## 49 CFR Part 571

[Docket No. 74-09; Notice 18]

Federal Motor Vehicle Safety  
Standards; Child Restraint SystemsAGENCY: National Highway Traffic  
Safety Administration (NHTSA),  
Department of Transportation.

ACTION: Final rule.

Figure 6. Pre-impact Buckle Release Force Test Set-up

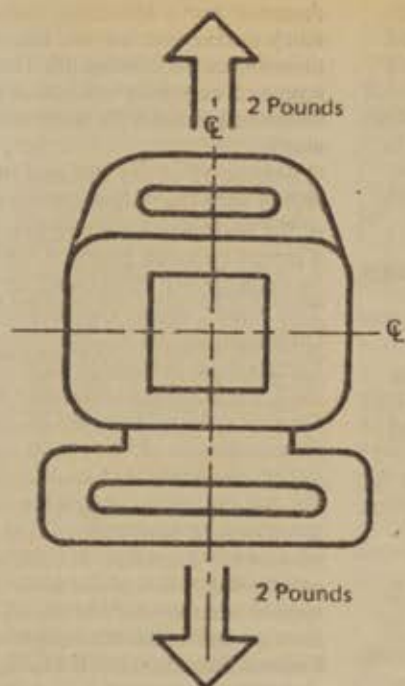
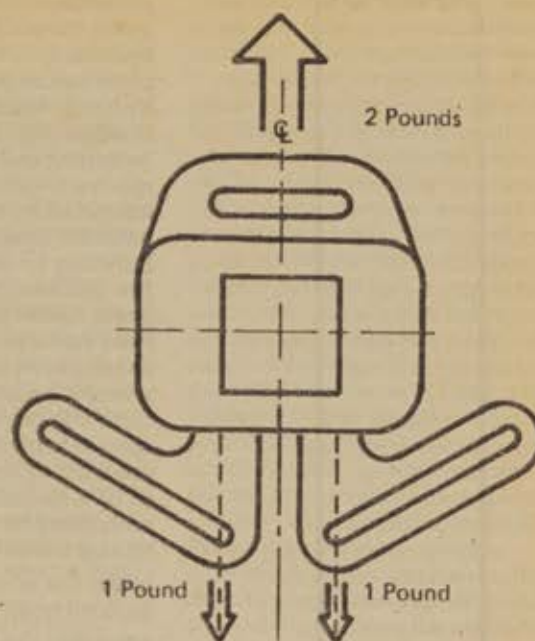
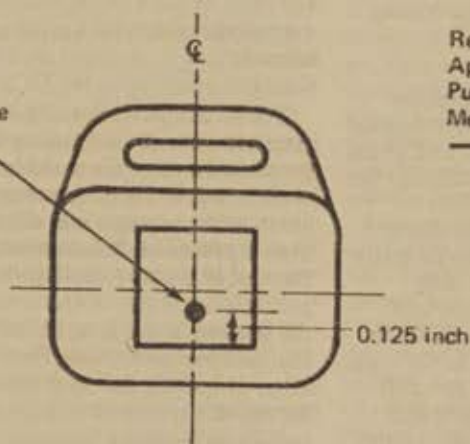
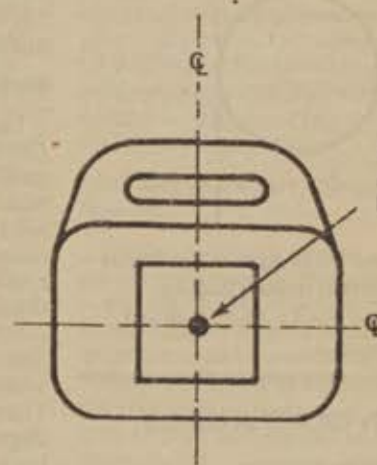
The agency agrees with the commenters that some further refinements should be made to the test procedures to account for the different types of push buttons. Accordingly, this rule specifies that, for hinged buttons, the force shall be applied according to the procedures proposed in the NPRM. For floating buttons, the force shall be applied at the geometric center of the button. These differing force application points will take into account the differing designs of push buttons, without favoring one or the other design.

degrees). For pushbutton release mechanisms with a fixed edge (referred to in Figure 6 as "hinged button"), the release force shall be applied at the centerline of the button, 0.125 inches away from the movable edge directly opposite the fixed edge, and in the direction that produces maximum releasing effect. For pushbutton release mechanisms with no fixed edge (referred to in Figure 6 as "floating button"), the release force shall be applied at the center of the release mechanism in the direction that produces the maximum releasing effect. For all other buckle release mechanisms, the force shall be applied on the centerline of the buckle lever or finger tab in the direction that produces the maximum releasing effect. Measure the force required to release the buckle. Figure 6 illustrates the loading for the different buckles and the point where the release force should be applied, and Figure 7 illustrates the conical surface used to apply the release force to pushbutton-release buckles.

S6.2.1 Before conducting the testing specified in S6.1, place the locked buckle on a hard, flat, horizontal surface. Each belt end of the buckle shall be pre-loaded in the following manner. The anchor end of the buckle shall be loaded with a two pound force in the direction away from the buckle. In the case of buckles designed to secure a single latch plate, the belt latch plate end of the buckle shall be loaded with a two pound force in the direction away from the buckle. In the case of buckles designed to secure two or more latch plates, the belt latch plate ends of the buckle shall be loaded equally so that the total load is 2 pounds, in the direction away from the buckle. For pushbutton-release buckles the release force shall be applied by a conical surface (cone angle not exceeding 90

8. Two new drawings (Figures 6 and 7) are added at the end of § 571.213, appearing as follows:

Figure 7. Release Force Application Device —  
Push Button Release Buckles  
[FR Doc. 85-19907 Filed 8-20-85; 8:45 am]  
BILLING CODE 4910-57-M

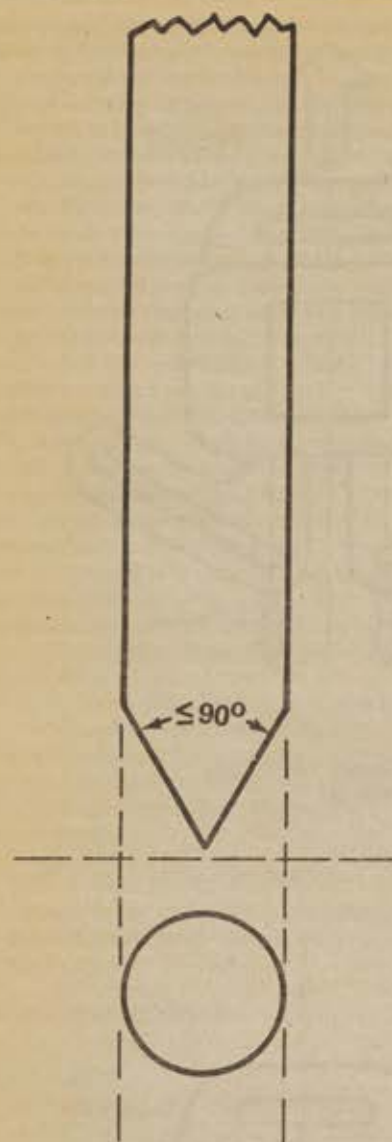
NHTSA had decided to adopt the proposed conical test device. Its small contact area allow accurate positioning on the release button, which will yield consistently repeatable test results. The buckle release force test procedures proposed in the NPRM, as modified for this final rule, were conducted by the Calspan Corporation in July 1984 during the annual FMVSS No. 213 compliance test procedures. On the basis of these tests, the agency concluded that the amended test procedures simulate real world actuation of push button release mechanisms because the release force is applied in a manner similar to hand

S6.2.4 While applying the force specified in S6.2.3, and using the device shown in Figure 7 for pushbutton-release buckles, apply the release force in the manner and location specified in S6.2.1 for the type of buckle. Measure the force required to release the buckle.
